Boundary Survey for  
JERRY N THOMPSON  
JOAN THOMPSON  
A168 = O.31AC

**APPLICANT:** J. W. Thompson **PETITION NO.:** V-3  
**PHONE:** 770-597-8139 **DATE OF HEARING:** 01-13-10  
**REPRESENTATIVE:** same **PRESENT ZONING:** R-30  
**PHONE:** same **LAND LOT(S):** 776, 809  
**PROPERTY LOCATION:** Located on the west side of Wingard Drive, north of Meadowview Drive (1787 Wingard Drive). **DISTRICT:** 16  
**SIZE OF TRACT:** .5 acre  
**COMMISSION DISTRICT:** 3

**TYPE OF VARIANCE:** 1) Allow an accessory structure to the side and front of the primary structure and waive the side setback for said structure from the required 12 feet to 5 feet adjacent to the southern property line and the front setback from the required 45 feet to 35 feet; and 2) waive the side setback for an existing shed from the required 12 feet to 1 foot adjacent to the southern property line and the rear setback from the required 40 feet to 36 feet on lot 20.

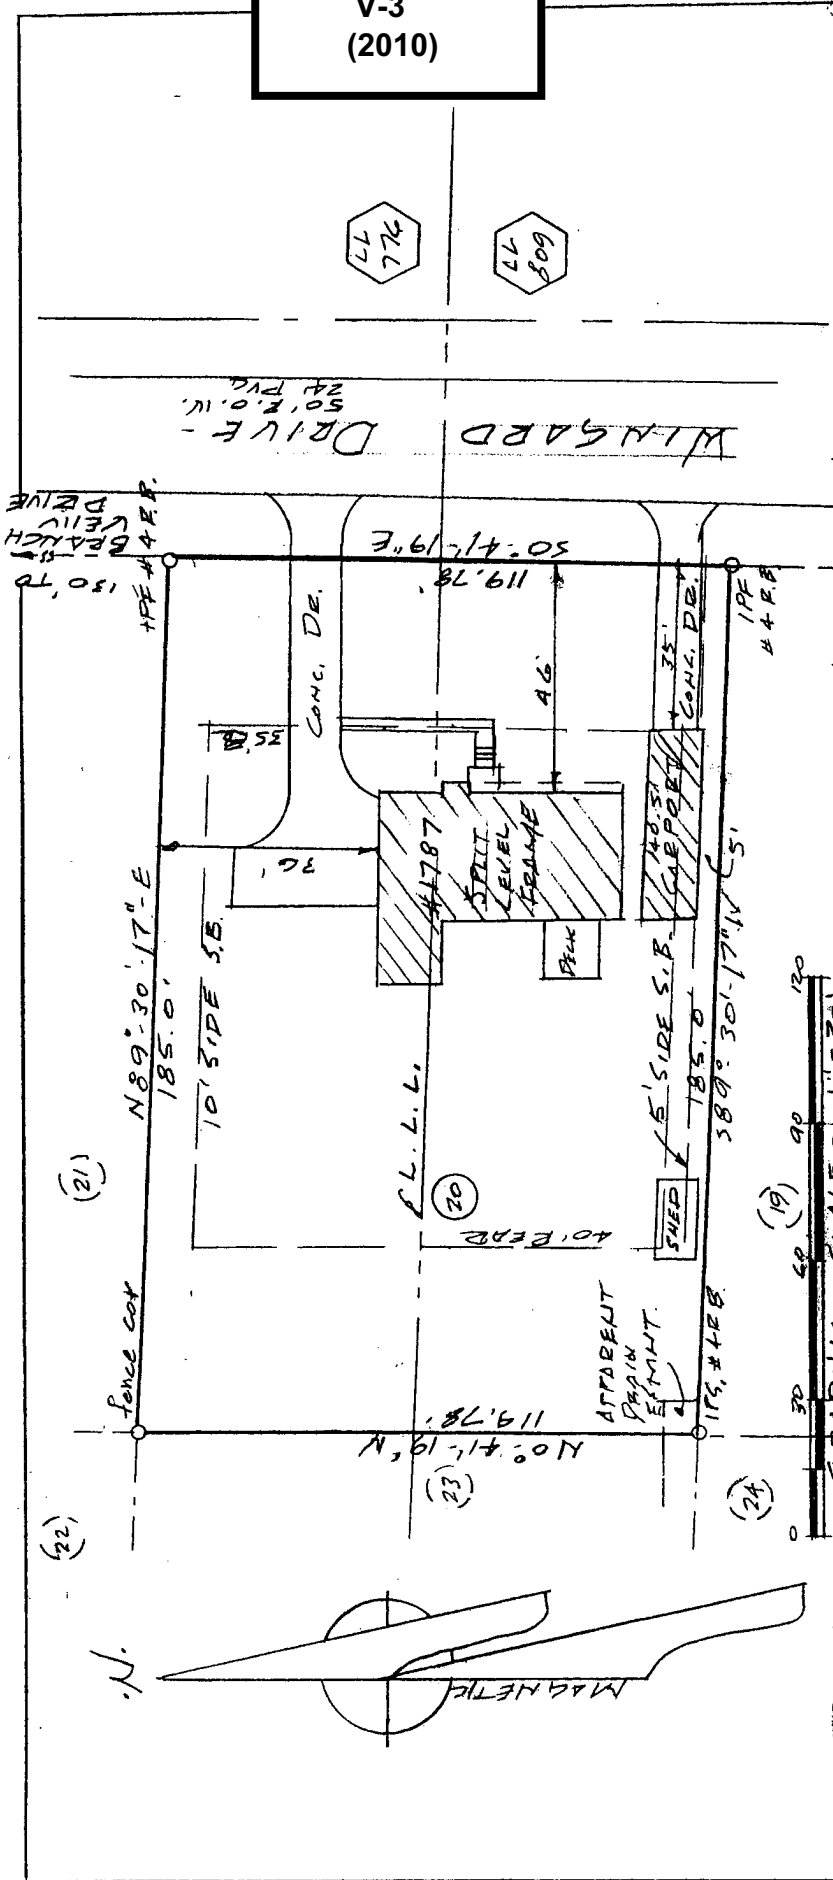
**DEVELOPMENT & INSPECTIONS:** If the variance is approved, all construction within 5 feet of the property line will require a one hour rating. Roof eave projections cannot exceed 4 inches if located within 2 feet of the property line. If this variance request is approved, a subdivision plat revision must be recorded reflecting the revised setback. The surveyor must submit the plat to the Site Plan Review Section, Community Development Agency for review and approval prior to recording. For questions, call 770-528-2147.

**STORMWATER MANAGEMENT:** No apparent adverse stormwater impacts are anticipated. The RV shed is located over an existing driveway and the shed drains through the rear of the adjacent parcel to an existing drainage swale.
